Meeting: Zoning Board of Adjustments

Date: February 19, 2025

RE: 361 Hanover St.

# BUILDING HEIGHTS OF ABUTTING PROPERTIES

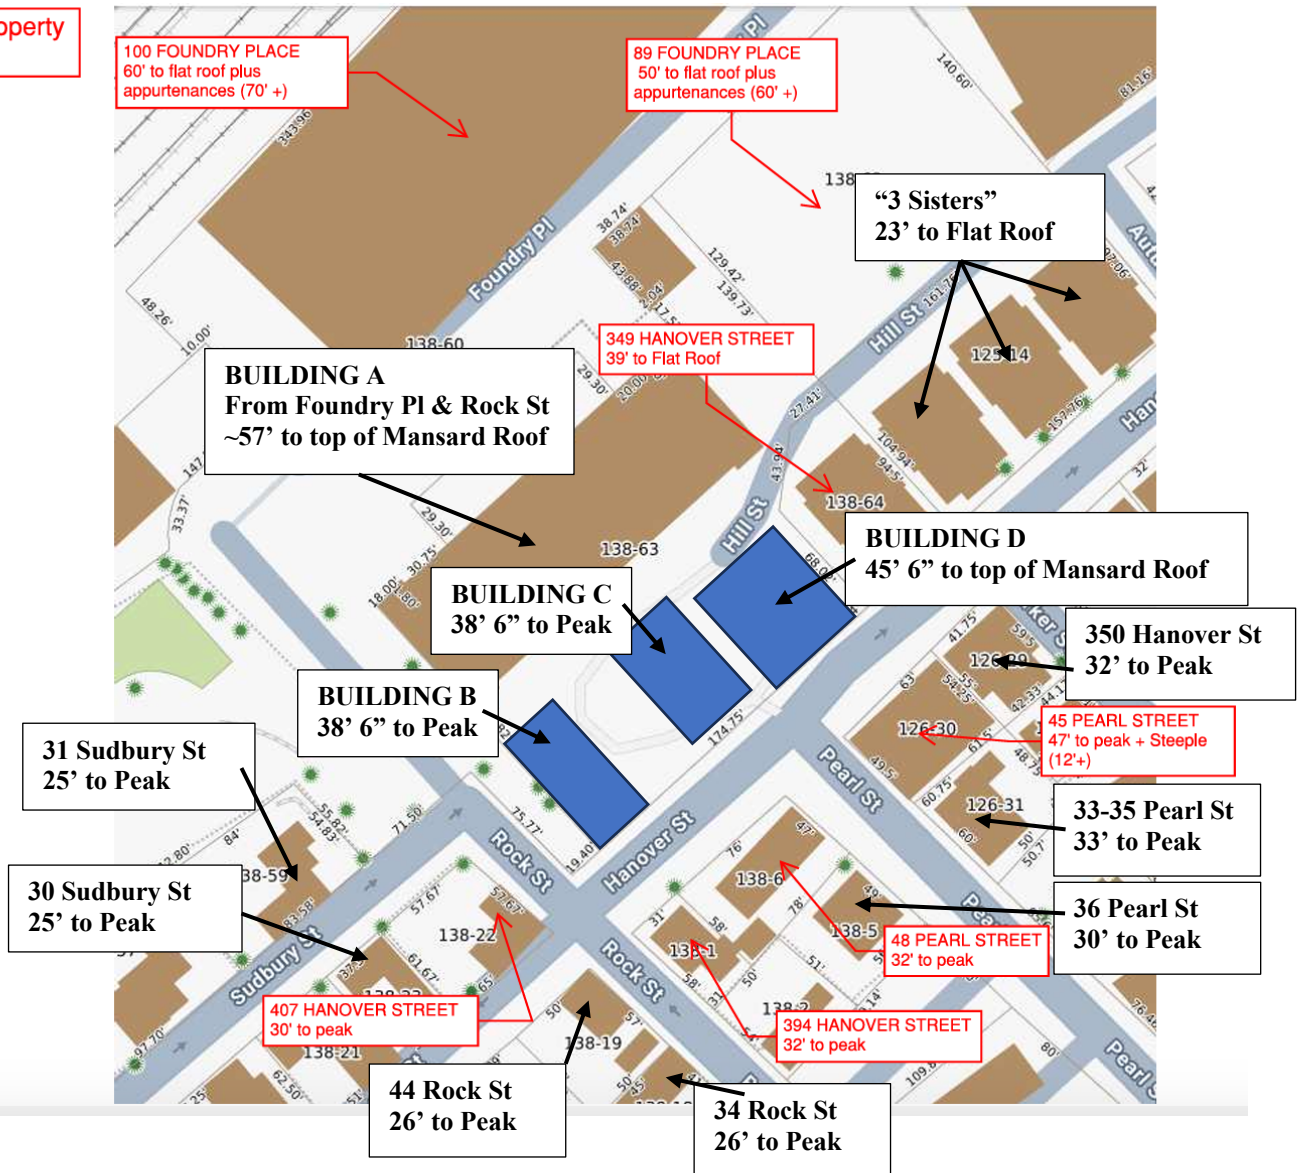
I still have significant concerns regarding the massing and heights\* of the buildings (Building D in particular) which dwarf the small homes in our neighborhood as well as the location of the entrance on Hanover Street as the traffic study contained numerous significant errors invalidating the results. While these issues will be more directly addressed in the upcoming TAC meetings, these issues should still be considered relevant to the requested variances for this proposed development.

\*See attached “Building Heights of Abutting Properties” – HDC neglected to include many of our neighborhood properties in their included comparison, all of which are significantly shorter than the proposed buildings for 361 Hanover Street.

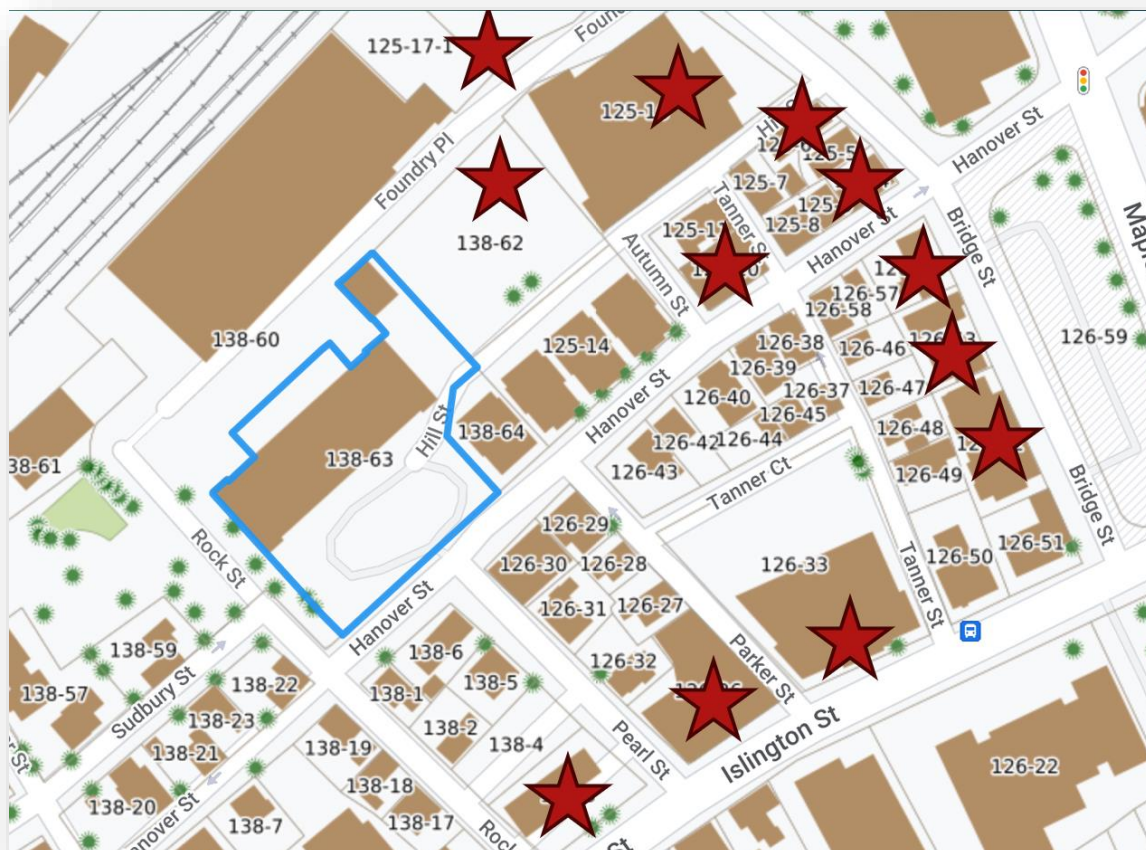
I attach a color copy of Figure # 7 which is included in the 361 Hanover Application that was submitted to the Zoning Board of Adjustment (the “ZBA”). Hill-Hanover is an abutter to the 361 Hanover Property. Hill-Hanover owns the three (3) buildings located on Lot 125-14 as shown on Figure # 7. These 3 buildings are located on Hanover Street and abut a private Right of Way in the back known as Hill Street. The Right of Way known as Hill Street is also shown on Figure # 7 and runs from the 361 Hanover Property, behind the 3 buildings owned by Hill-Hanover, to Autumn Street. The Right of Way then continues to Bridge Street. The Hill Street Right of Way is narrow. My client’s tenants also have the legal right to park their personal vehicles along this private Right of Way.

SITE PLAN

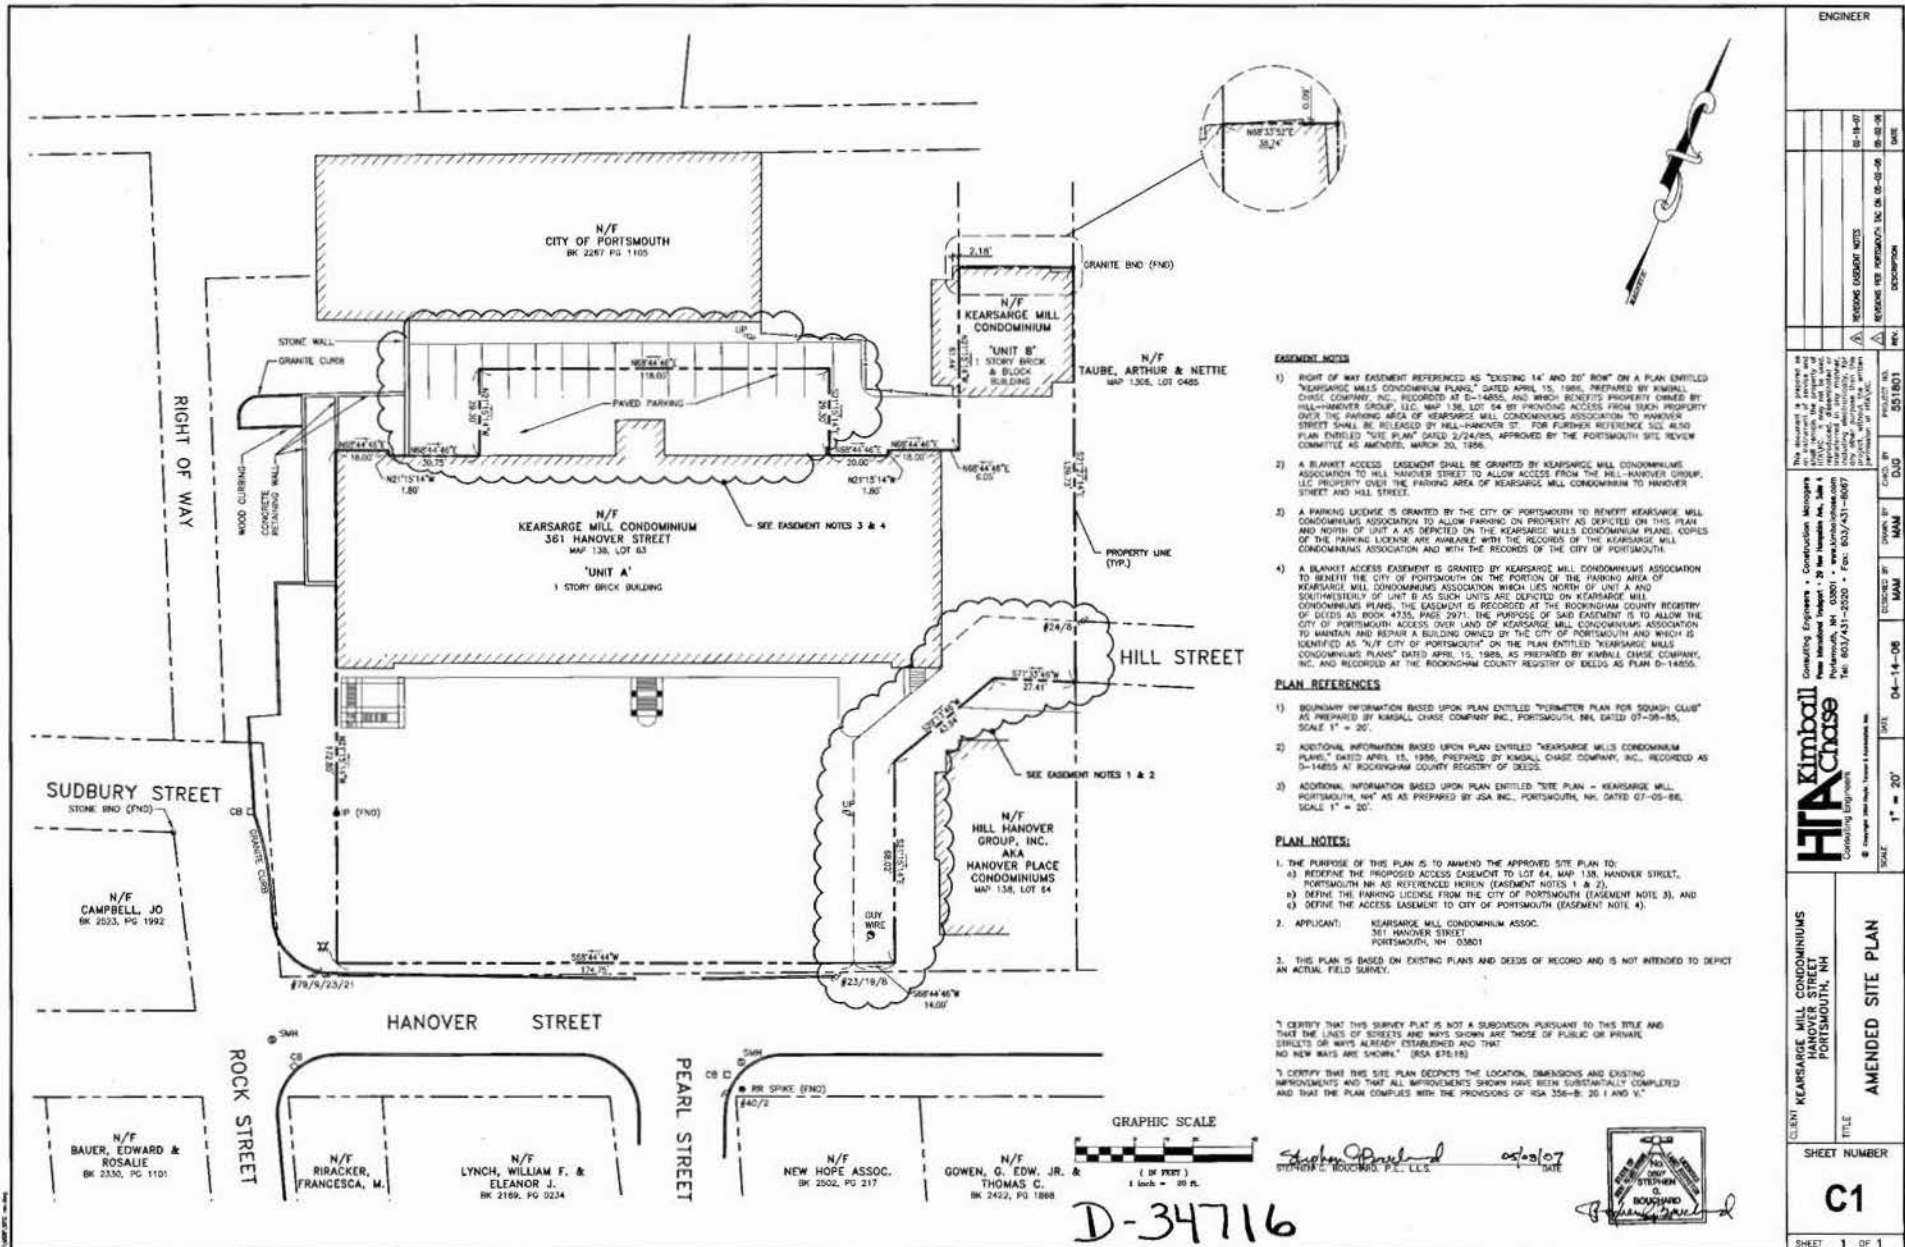
I next attach a color copy of the 361 Hanover Site Plan included as part of its Application submitted to the ZBA. The Site Plan indicates the existing Building "A" will contain thirty-four (34) Units. The Rowhouse identified as Building "B" will contain four (4) Units. The Duplex identified as Building "C" will contain two (2) Units. The Apartment Building identified as Building "D" will contain eight (8) Units.

Based on the above, 361 Hanover is unable to meet the necessary criteria to satisfy its request for the Variance referenced above. Specifically, the values of surrounding properties will be diminished by granting the Variance. Use of the private, narrow Right of Way by ingress and egress by the 34 Units proposed in Building "A," the 4 Rowhouse Units identified in Building "B," the 2 Duplex Units identified in Building "C," and the 8 Apartment Units identified in Building "D," will, without question, diminish the value of my client's Property. Simply put, the use of this Right of Way as a thoroughfare essentially from Bridge Street to the 361 Hanover Property will certainly diminish the value of my client's Property. Additionally, the Unit owners in my client's 3 Buildings already legally park along the private Right of Way known as Hill Street. Continued back-and-forth traffic would cause significant issues along this private Right of Way. It is also likely that residents of the new 361 Hanover Development and/or their guests will attempt to park along the private Right of Way, which will further diminish the value of my client's Property.
